LATE REPRESENTATIONS SCHEDULE
PLANNING COMMITTEE – 11TH OCTOBER 2017

PAGE NO. 1	APPLICATION NO. 16/02934/MJR
ADDRESS:	WINDSOR BUILDINGS FERRY ROAD
FROM:	The Architect (in response to the Planning Officer's invitation to withdraw the application)
SUMMARY:	Has forwarded the attached letter
REMARKS:	<p>Noted. The Architect defends the concept of the scheme and the design process behind it; and cites a number of developments in Cardiff and London which have similar features, and also provides some theoretical layouts of alternatives for the Ferry Road site development if it were to encompass the area of the motor repair garage.</p> <p>The letter conveys a contrary view of the development proposals to that held by the planning officer, making particular reference to the single aspect nature of the development, the finned screen, the privacy implications of the entrance to the occupier of flat 1, the relationship with the adjacent site; and the relationship with the development in respect of the adjacent street trees.</p> <p>All of these issues raised are covered within the report, and none of the examples are the scheme before planning committee to determine, which has it's own particu

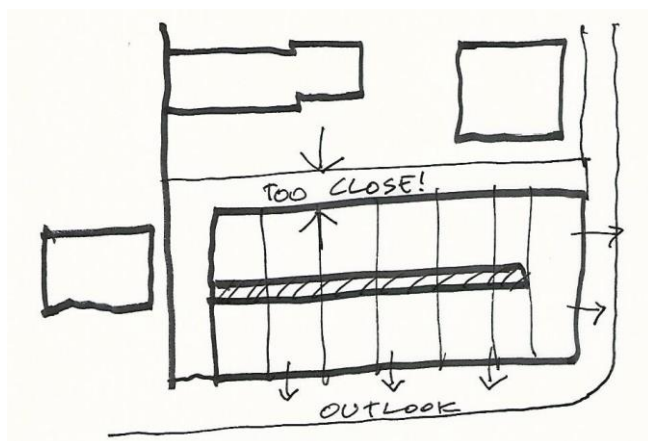
It is implied that the development of the application site on its own will prevent future development of the adjacent garage. In order to help his understanding of a future phase we provided an outline sketch or block plan indicating how a housing development here might proceed.

You have stated that you are not convinced by the sketch. We can demonstrate why this is not only an effective way of developing the site, but that it is probably the only feasible way (financially and practically) of developing it, given the site constraints.

Option 1: Dual Aspect

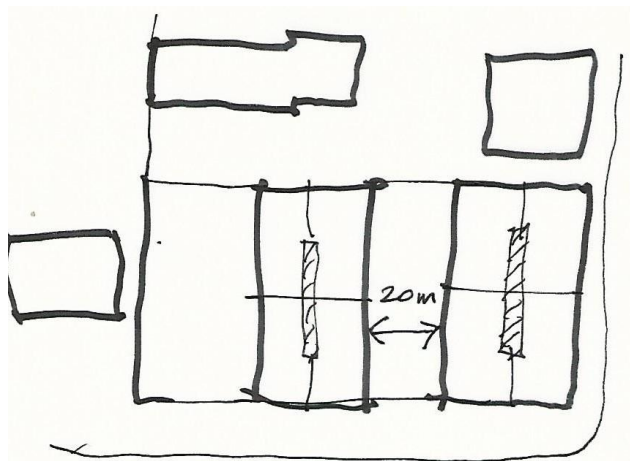
It can be seen immediately that this would require overlooking of the west boundary from a distance of around 4m and would be unacceptable.

Option 2: Two Blocks with courtyard gardens

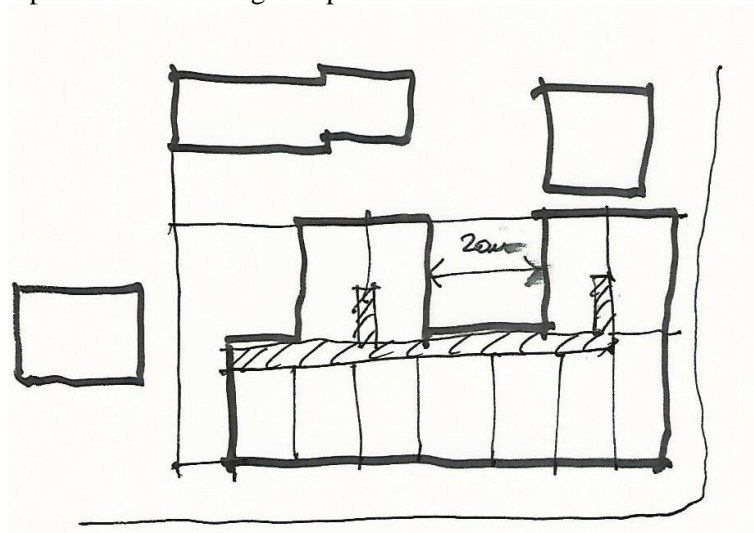
We could try turning the dual aspect flats through 90°, (fig 2). This would result in two blocks, with minimum 20m spaces between. This would allow 24 flats, but with a somewhat interrupted street scene, and open spaces which are not pleasant. There is no central access point, leading to ambiguity and decreased security.

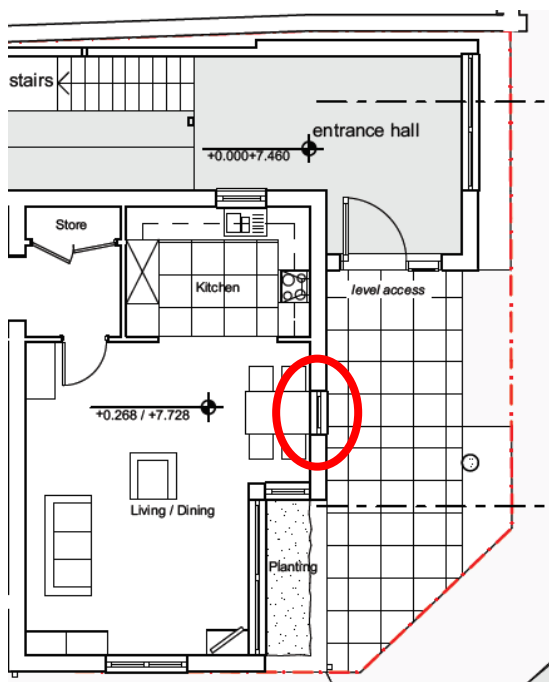
Following the Inspector's comments regarding the quality of amenity space provided as part of the previous scheme significant amendments were made. The winter garden idea evolved

out of a desire to provide secure amenity space, which would provide attractive space to spend time throughout the year, regardless of inclement weather. The winter garden design could be fitted with large opening (sliding) windows which would enable residents to enjoy fresh air in warmer weather but would still allow them high levels of security. In response to the comment regarding daylight now needing to pass through two sets of glazing to enter the living rooms we would suggest that the residents now effectively have two living rooms. The winter garden element can be used during the day time as a living area as well as an outside amenity area. After dark the residents would be more likely to retreat further into the flat. Therefore, residents will have the choice regarding where they want to locate within the flat and this will provide them with flexibility depending on their preference with regard to privacy, natural light levels or climatic temperature. Future residents would also of course have the opportunity to erect curtains across the front windows of the winter garden area if they wished to have more privacy etc.

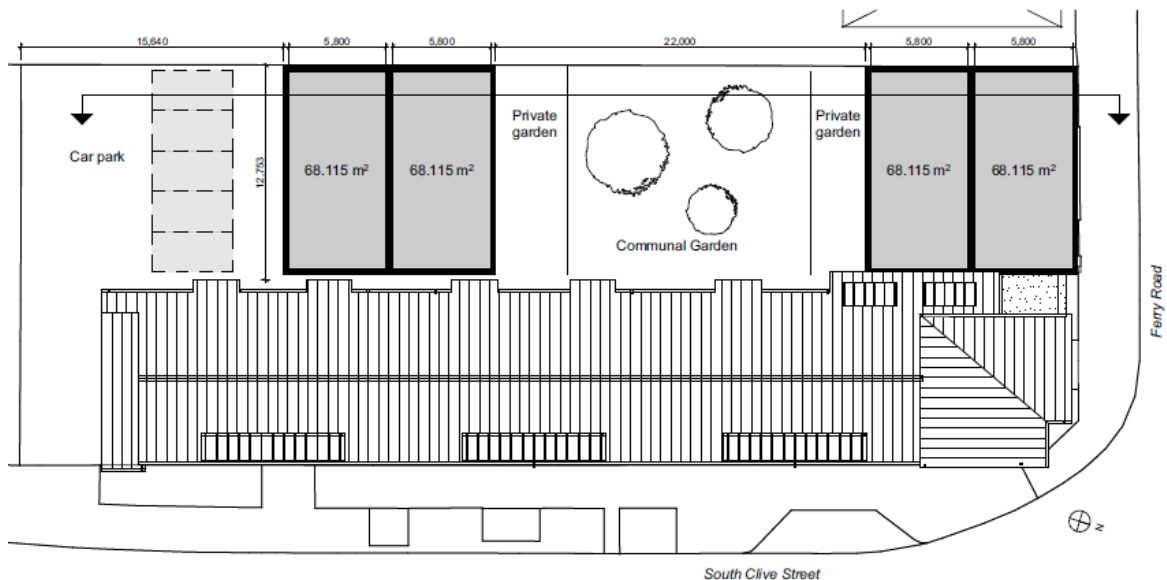
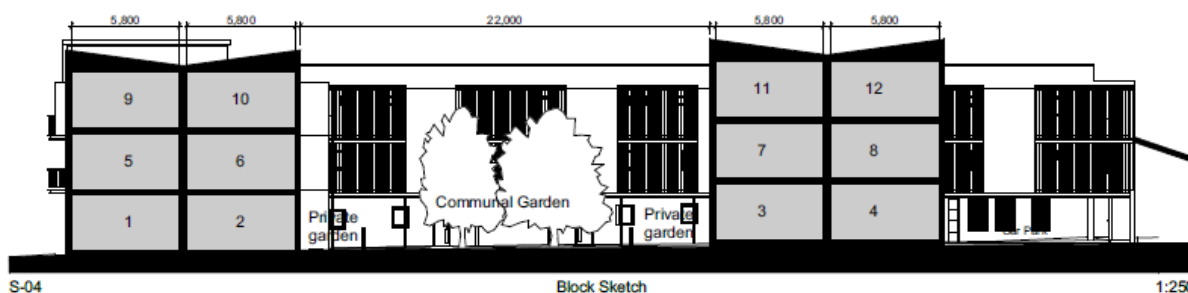
3. *'The development by virtue of whole site coverage and design is considered to be prejudicial to the future development of the land to the west, contrary to policies KP5: [GOOD QUALITY AND SUSTAINABLE DESIGN] and H6: [CHANGE OF USE OR REDEVELOPMENT TO RESIDENTIAL USE] of the Cardiff Adopted Local Development Plan 2016'.*

The above reason for refusal is completely at odds with the conclusion of the Inspector for the previous appeal on this site. The Inspector concluded on this matter:

'Whilst I recognise that a comprehensive approach to the development of these sites might be desirable, it is clear from the evidence presented that the sites could, in principle, be developed independently'.

The site plan below is purely indicative, and has been drafted to show how the adjacent site could be developed at a future date alongside the development subject of this application. The scheme shown below, whilst only in sketch form complies with all adopted guidance regarding privacy distances etc.

Recommended reason for refusal no.3 is not only unreasonable and at odds with the view of the Inspector it unfairly effectively leaves the applicant entirely beholden to the owner of the adjacent property, who has repeatedly declined to enter into dialogue regarding the sale, or redevelopment of his site.
